## **5.0 Reactor Coolant System and Connected Systems**

### **5.1 Summary Description**

The information in this section of the reference ABWR DCD, including all subsections and figures, as modified by the STP Nuclear Operating Company Application to Amend the Design Certification rule for the U.S. Advanced Boiling Water Reactor (ABWR), "ABWR STP Aircraft Impact Assessment (AIA) Amendment Revision 3," dated September 23, 2010 is incorporated by reference with the following departures.

Figure 5.1-1 Rated Operating Conditions of the ABWR

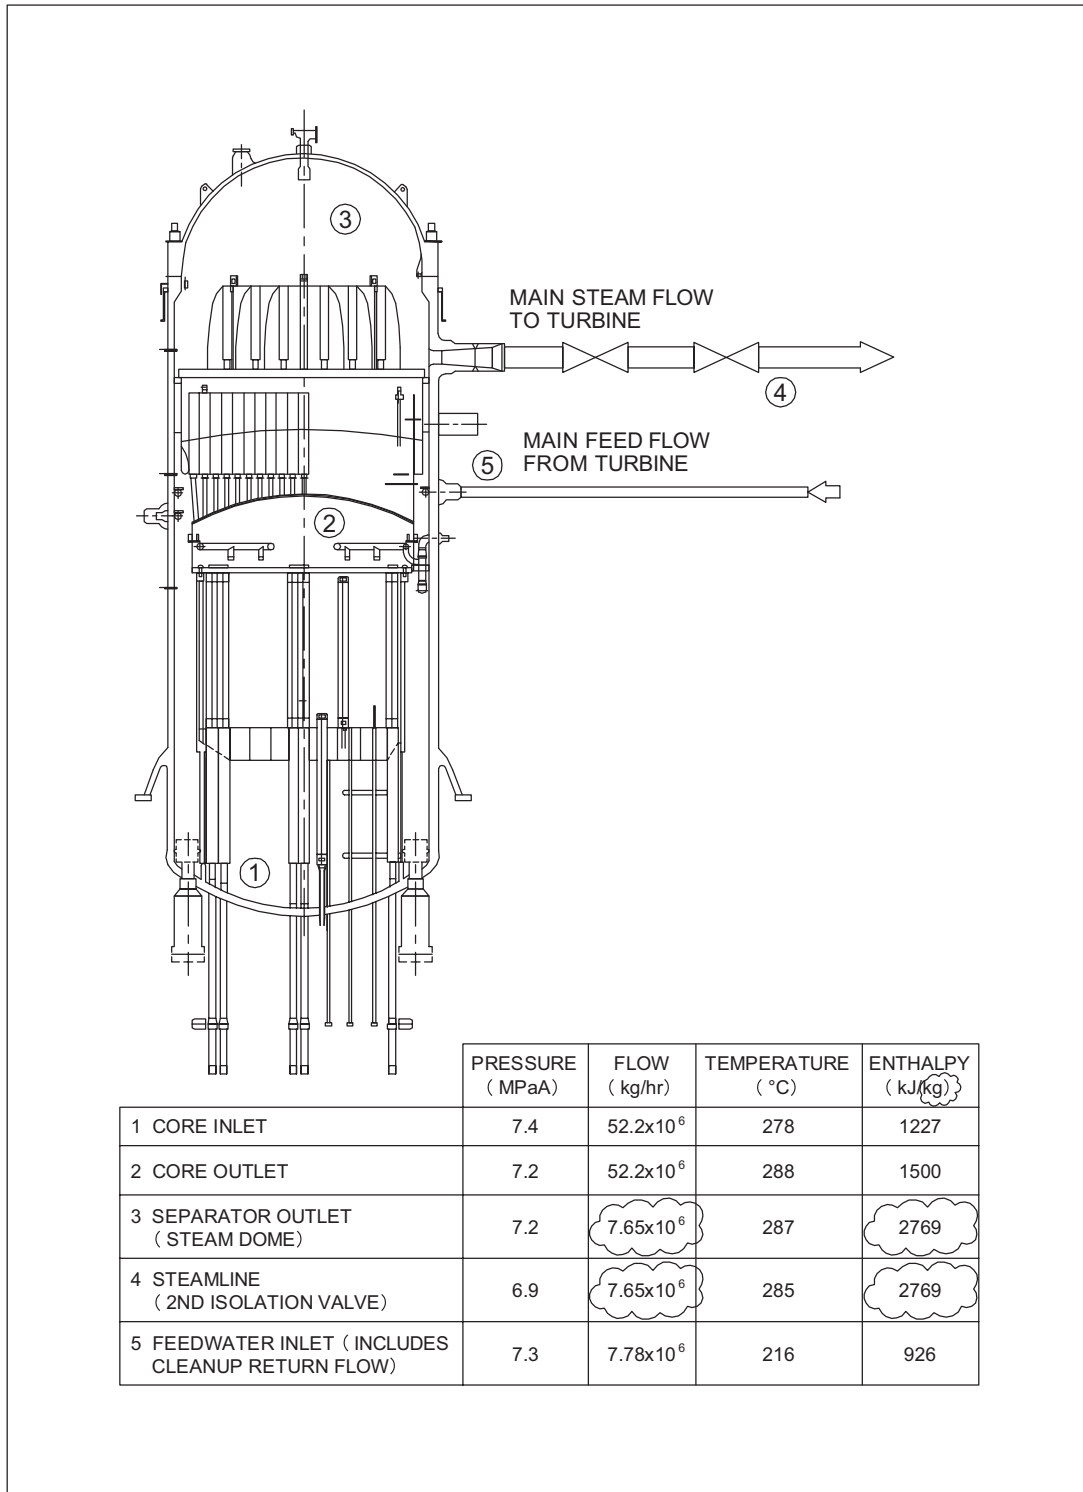
STP DEP 10.1-3 (Figure 5.1-1)
